Access Compliance Report Public Rights-of-Way (Curb Ramps)

Main Street: HARDING PL Cross Street: N/A Location: W Intersection ID: 10027950 Initial Pass/Fail: Fail **Overall Compliance: No** ADA ID: 374FB63353C4 Ramp Type: Combination1 **Severity Score:** 37.5

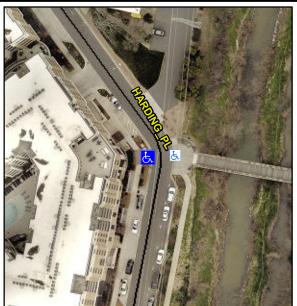
n ossible solution		i ieiu ivie
Possible Solutions:	Compli	ance Description
Remove & Replace Entire Ramp.	N/A	Ramp Length LT (in)
·	Yes	Ramp Width LT (in)
	Yes	Ramp Slope LT (%)
	Yes	Ramp XSlope LT (%
	N/A	Ramp Length (in)
	Yes	Ramp Width (in)
Surveyor Notes:	N/A	Flare Type LT
N/A	N/A	Flare Slope LT (%)
	N/A	Flare Traversable LT
	N/A	Landing Length (in)
	N/A	Landing Width (in)
PROW/ADA:	N/A	Landing Slope (%)
Not Found, R304.5.3, R304.3.2	N/A	Landing X Slope (%
	N/A	Landing Curb? (Y/N
	N/A	Shared Landing?
	N/A	Gutter Ponding?
	N/A	Gutter Lip Ht (in)
	N/A	Painted X Walk1?
		X Walk 1 Direction
		X Walk 1 Width (in)
		X Walk 1 Slope (%)
